CITY OF NOVI CITY COUNCIL SEPTEMBER 22, 2025

SUBJECT: Consideration of tentative approval of Mariella Estates, a 10-lot single family development, located north of Eight Mile Road, west of Garfield Road, to include a Zoning Map Amendment rezoning from Residential Acreage to R-1 with a Planned Rezoning Overlay. **FIRST READING**

Formal PRO Plan

Rezoning Request from RA Residential Acreage to R-1 One Family Residential with a Planned Rezoning Overlay

SECTION 31
TOWN 01 NORTH, RANGE 08 EAST
CITY OF NOVI
OAKLAND COUNTY, MICHIGAN
UTILITY PLAN

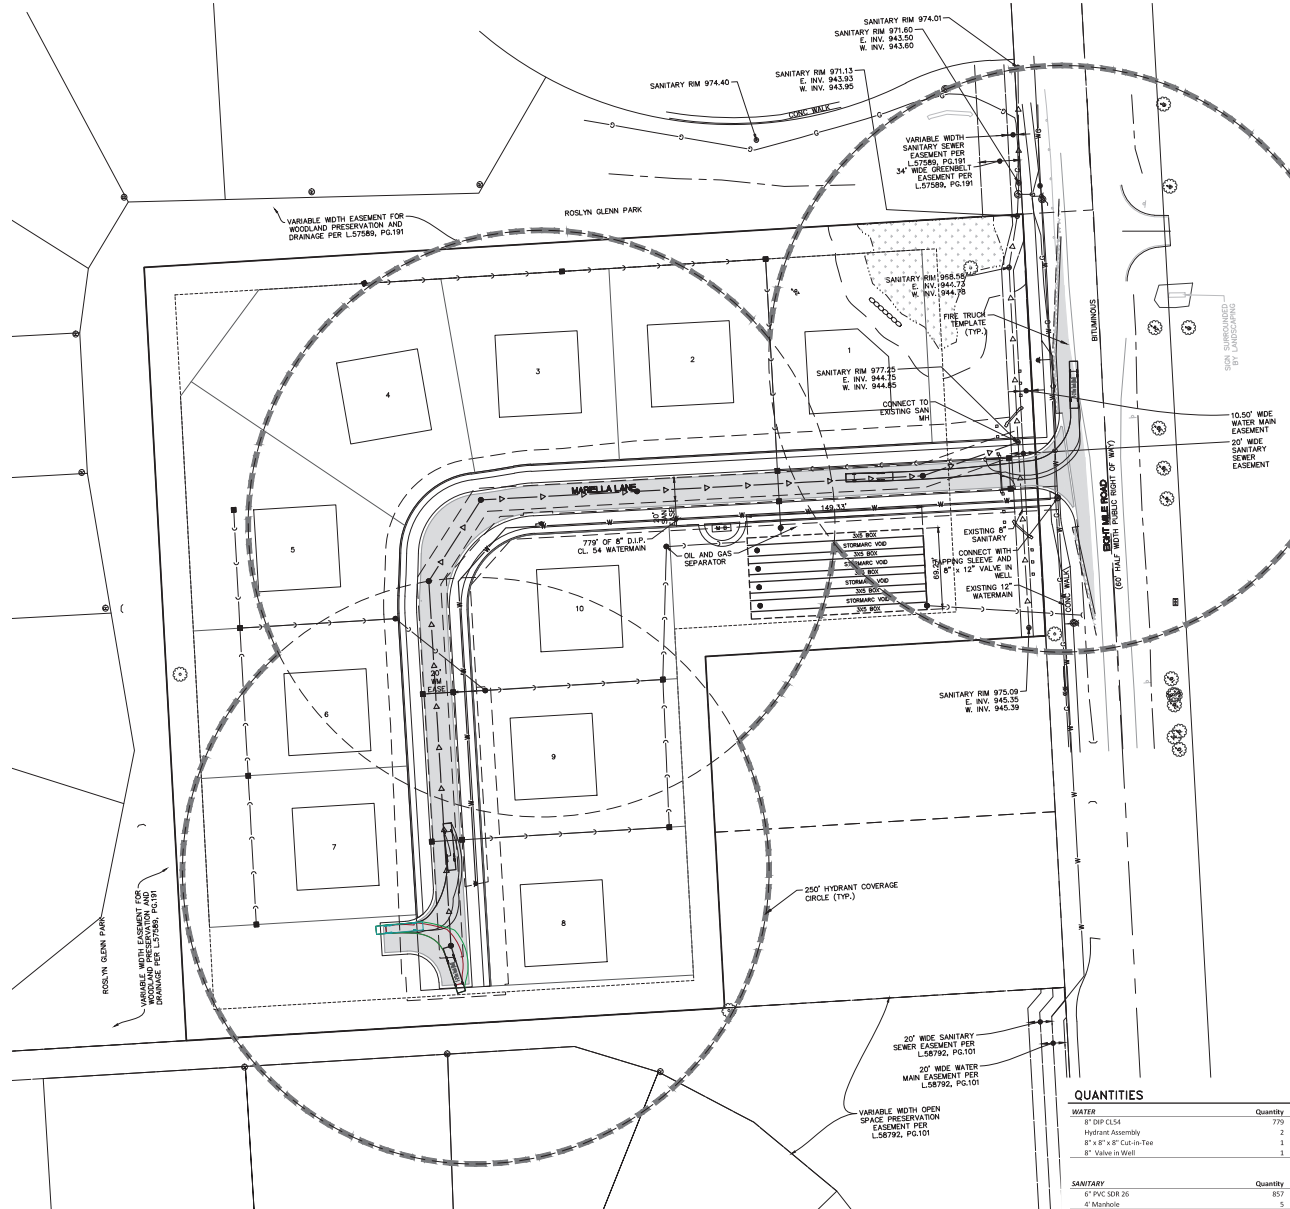
- **All fire hydrants *MUST* be installed and operational prior to any combustible material is brought on site. **IFC 2015 3312.1.** **ONE additional hydrant is needed near lot #1. Sheet #5 only shows 2 hydrants being added to new water main.****

- Fire apparatus access drives to and from buildings through parking lots shall have a minimum fifty (50) feet outside turning radius and designed to support a minimum of thirty-five (35) tons. **(D.C.S. Sec 11-239(b)(5)).** **Sheet #5 indicates 45’ turning radii. Have this updated and include 50’ turning capabilities.**

CLIENT: BRADIE BROTHERS, LLC
PROJECT: MARELLA ESTATES
CONCEPTUAL PLANNED
REZONING OVERLAY
LAYOUT PLAN

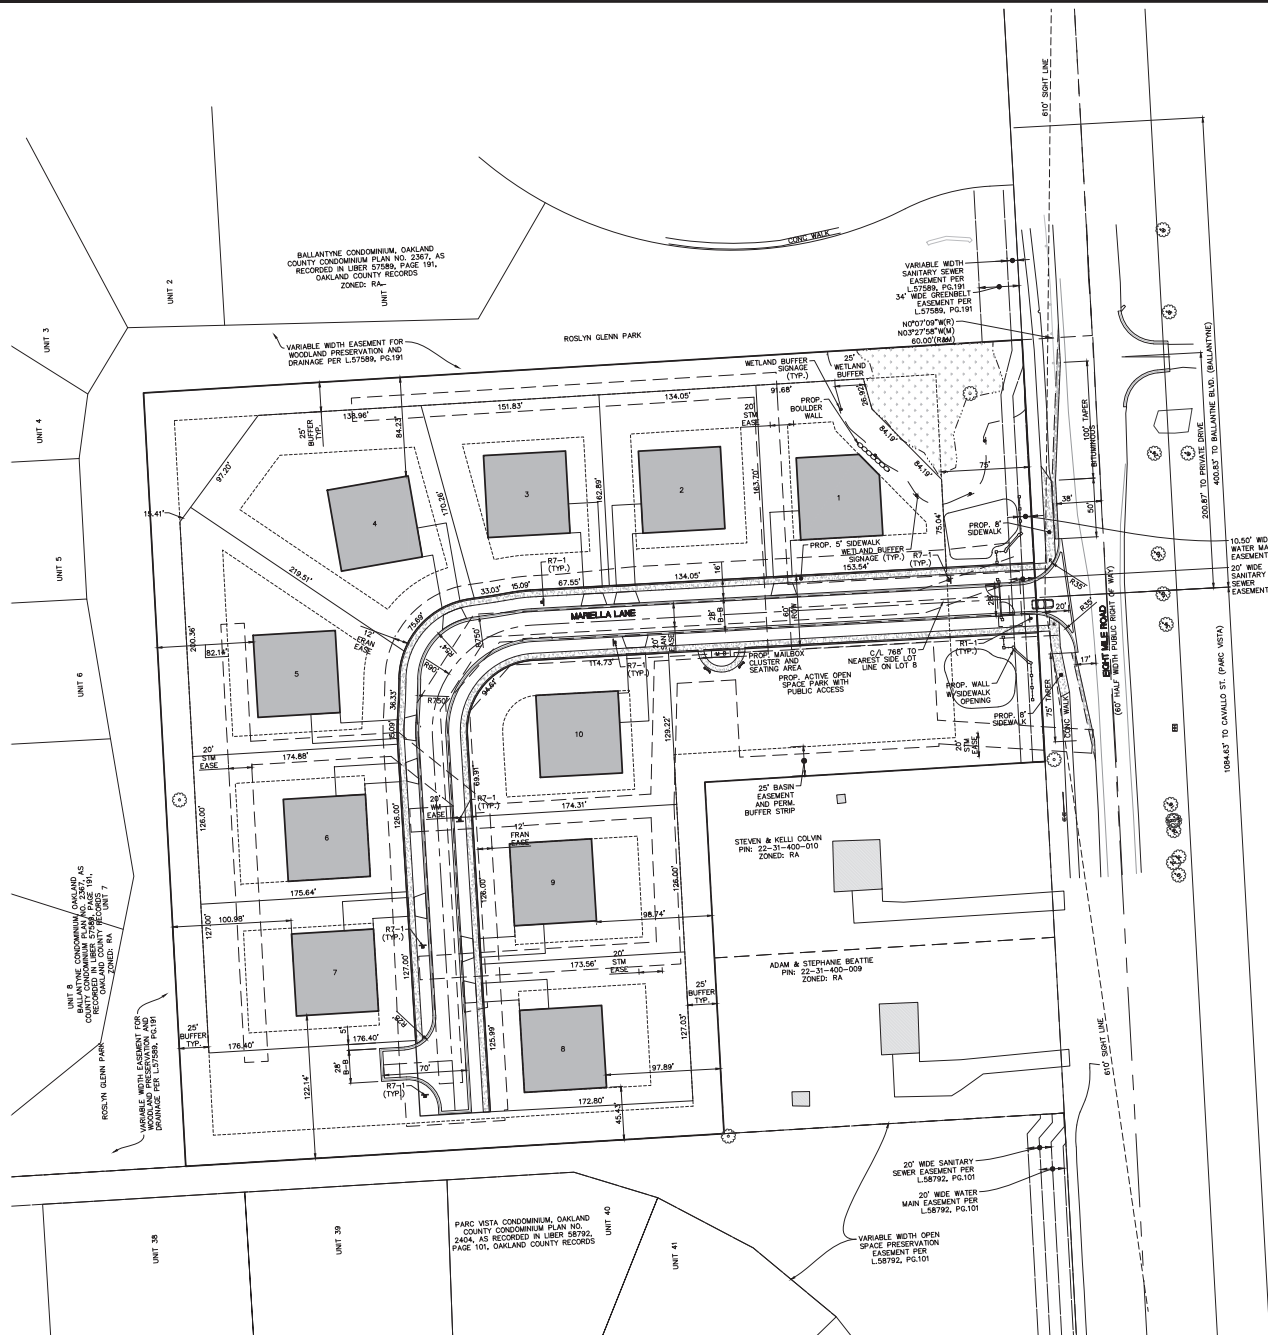
3. Sheet 04 Layout Notes state that the road will not be gated and that roads will be private, the plan shows a gate at the entrance and the road is labeled with 60' ROW. Clarify if roads will be private, revise note to state 60' private road ROW.

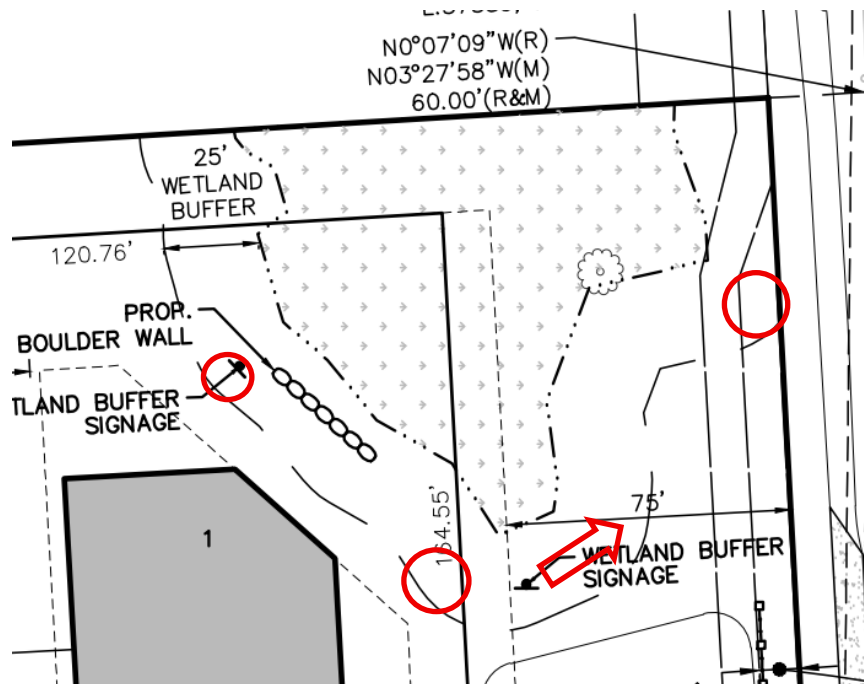
- a. Impacts resulting from the proposed boulder wall should be quantified (cubic yards and square feet) in future submittals.
- b. Impacts from proposed grading should be quantified (cubic yards and square feet) in future submittals. Additionally, if grading is proposed within the wetland setback, it should be identified with a unique symbol.

- c. It is requested that additional wetland and wetland buffer signage be placed around the remaining wetland to ensure the area will not be mowed or disturbed in the future. If possible, the signs should be placed as close to the outside edge of the setback buffer to ensure the full 25-foot setback is not mowed. In future submittals, an example sign rendering should be provided in the site plan. If a conservation easement is placed around the remaining wetland/wetland setback (Comment 4), the signs should indicate that the area is a protected conservation easement.
